Access Compliance Report

Public Rights-of-Way

(Curb Ramps)

Intersection ID: 26371	Main Street: BEVINGTON_PL	Cross Street: HEMINGFORD_CT	Location: NW
ADA ID: 7F6DB58C2E91	Ramp Type: PerpDiag	Initial Pass/Fail: Fail	Overall Compliance: No
		Severity Score: 25

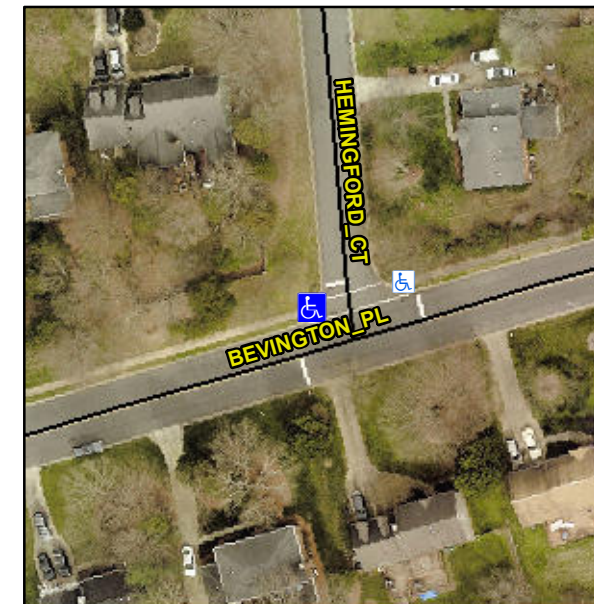
Not Found, R304.5.3

Compliance	Description	Data	Compliance	Description	Data
N/A	Ramp Length (in)	32.0	Yes	Ramp Slope (%)	6.1
Yes	Ramp Width (in)	48.0	No	Ramp XSlope (%)	8.2
N/A	Flare Type LT	N/A	N/A	Flare Type RT	N/A
N/A	Flare Slope LT (%)	N/A	N/A	Flare Slope RT (%)	N/A
N/A	Flare Traversable LT?	N/A	N/A	Flare Traversable RT?	N/A
N/A	Landing Length (in)	N/A	N/A	DWS Provided?	N/A
N/A	Landing Width (in)	N/A	N/A	DWS Contrast?	N/A
N/A	Landing Slope (%)	N/A	N/A	DWS Length (in)	N/A
N/A	Landing X Slope (%)	N/A	N/A	DWS Full Width?	N/A
N/A	Landing Curb? (Y/N)	N/A	N/A	DWS Offset (in)	N/A
N/A	Shared Landing?	N/A			
N/A	Gutter Ponding?	N/A	N/A	Gutter Slope (%)	N/A
N/A	Gutter Lip Ht (in)	N/A	N/A	Gutter X Slope (%)	N/A
N/A	Painted X Walk1?	No	N/A	Painted X Walk2?	Yes
	X Walk 1 Direction	To S		X Walk 2 Direction	To E
N/A	X Walk 1 Width (in)	N/A	N/A	X Walk 2 Width (in)	108.0
	X Walk 1 Slope (%)	1.4		X Walk 2 Slope (%)	0.1
	X Walk 1 X Slope (%)	0.8		X Walk 2 X Slope (%)	10.3

Remove & Replace Curb Ramp With Two New Directional Ramps or Equivalent.
